City of Turlock
Well 38 Arsenic Mitigation
And ICF Treatment

ADDENDUM NO. 2

**FOR: CITY OF TURLOCK
WELL 38 ARSENIC MITIGATION
AND ICF TREATMENT**

June 24,2020

P10-01

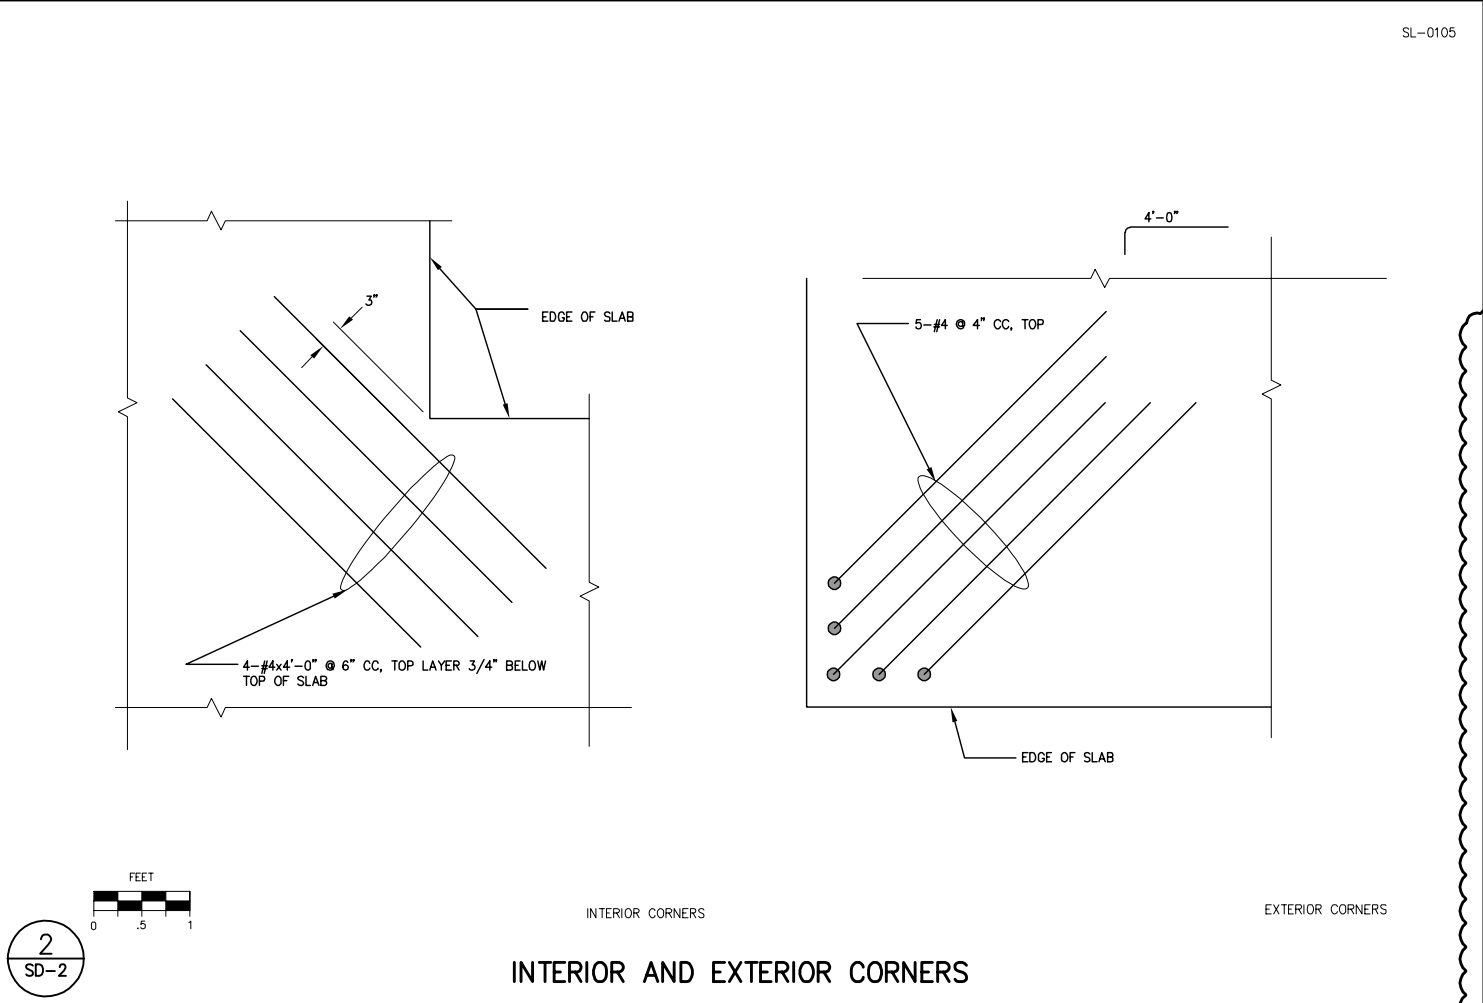
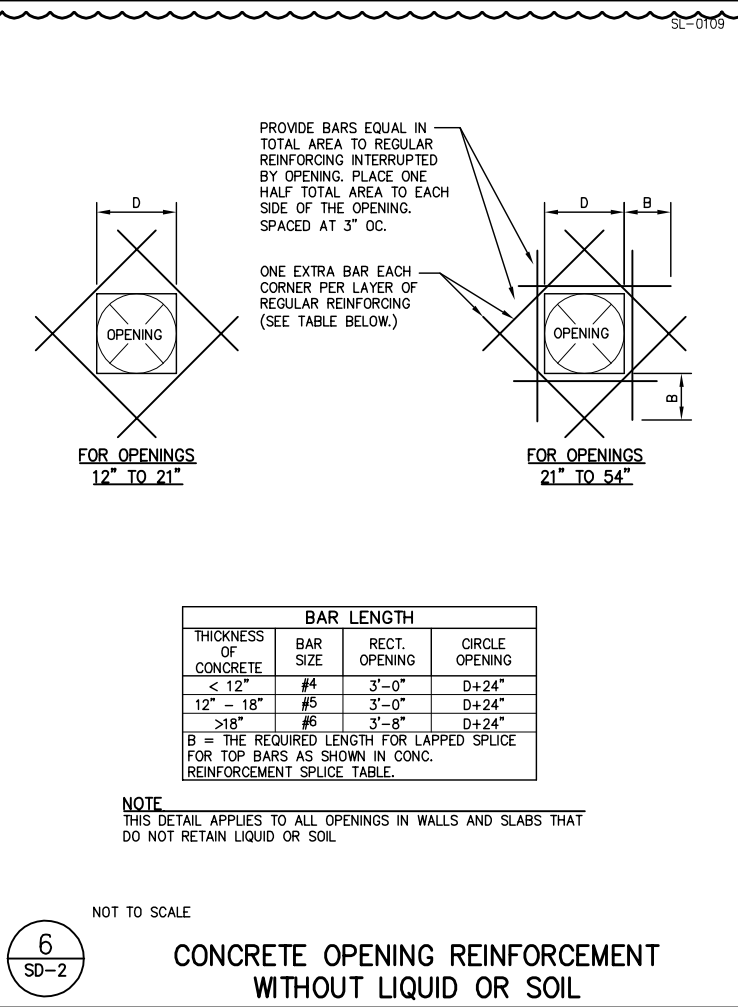
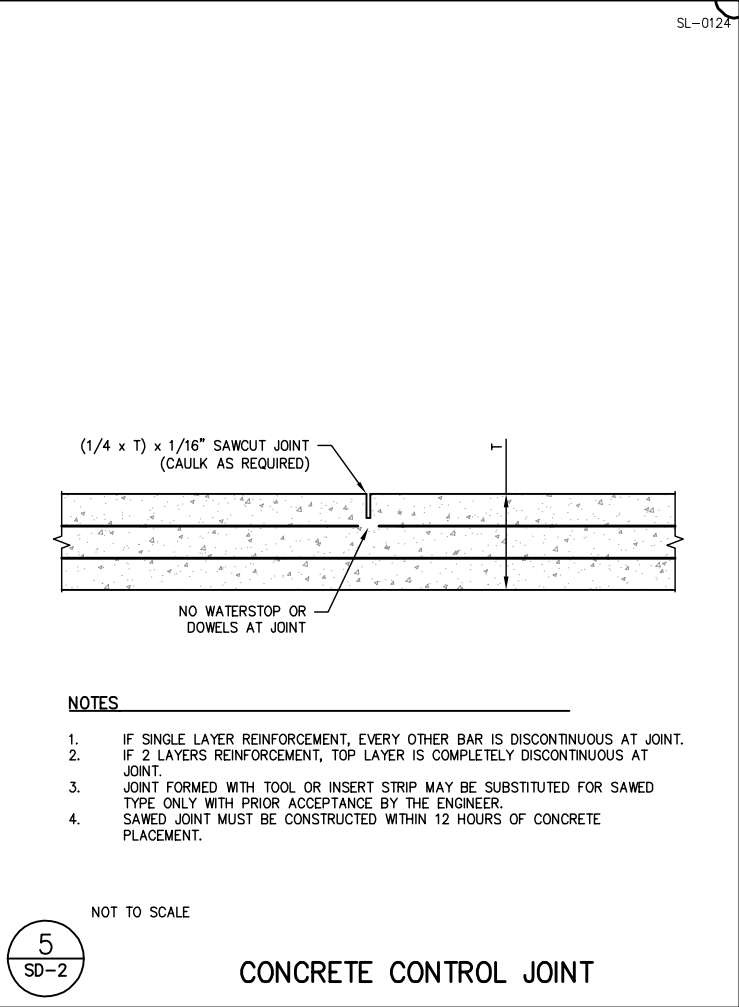
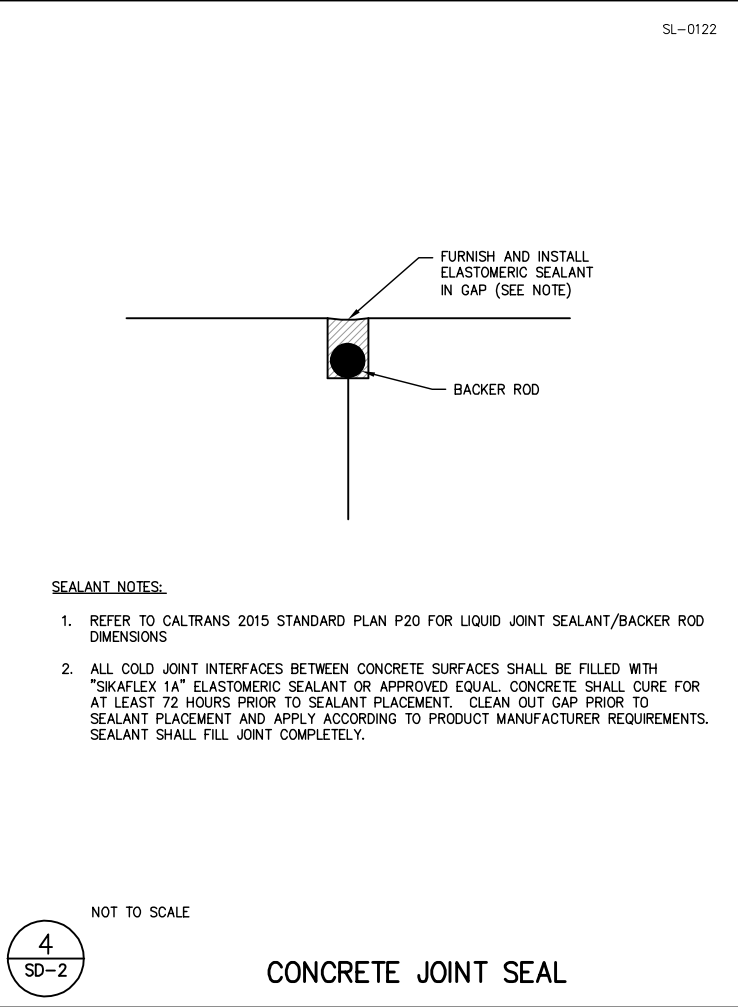
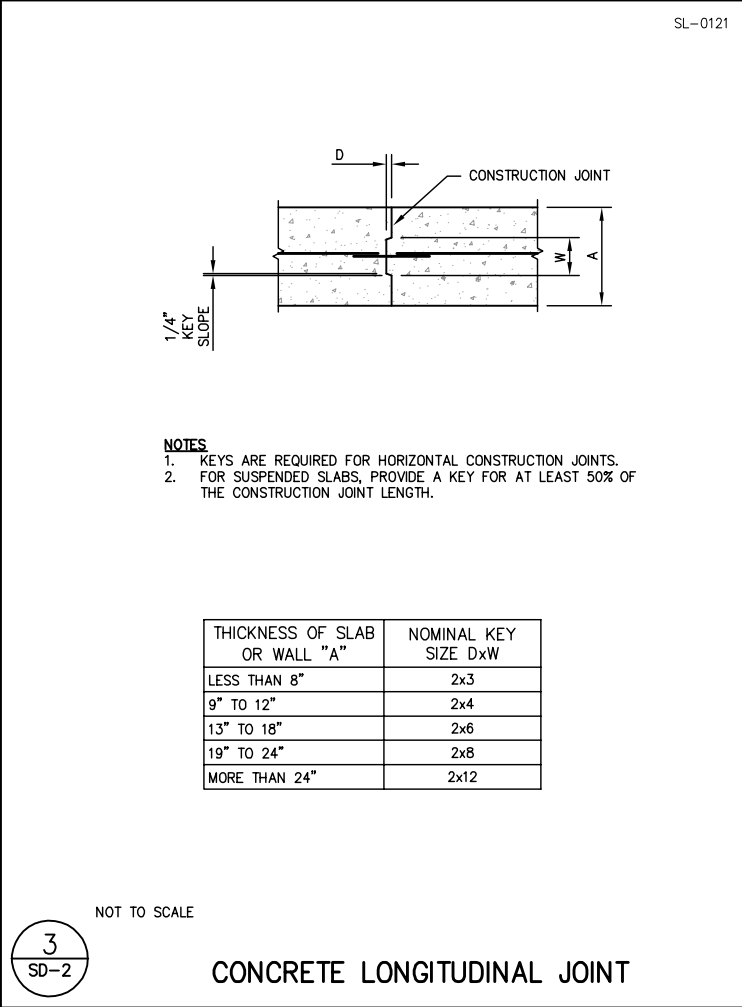
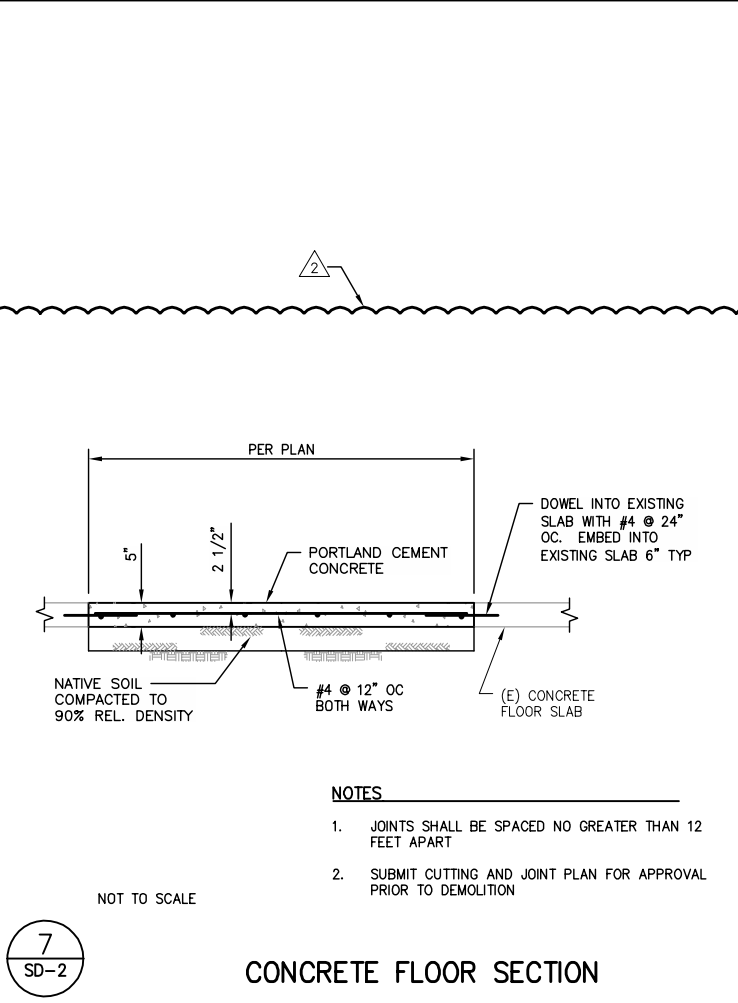
Question No. 9: Please specify the concrete foundation requirements for the Acoustiblok Sound Attenuator Panel called-out on in Item 16 on Sheet P10-01.

Question No. 22: Drawing E2.1 Existing Well Building – this drawing shows multiple conduit and feeder runs under or in slab. A major portion of the concrete floor will have to be removed and replaced to accommodate access from the equipment line up long the North wall. None of this work is shown on the Civil or Structural Drawings. Please clarify.

Answer No. 9: The foundation shall be 12" thick concrete with two layers of #5 rebar at 12" O.C.

Answer No. 22: *Concrete removal in the well building has been added to the Demolition Plan on C-3 and attached to this Addendum. The contractor shall replace the concrete in kind once conduit is placed and estimated extents of slab are shown on the revised Sheet P10-01 attached to this Addendum. See Plan Revision Item 11 this Addendum.*

Replace with the attached to sheets. Revisions made to clarify concrete pad replacement required based on electrical conduit replacements
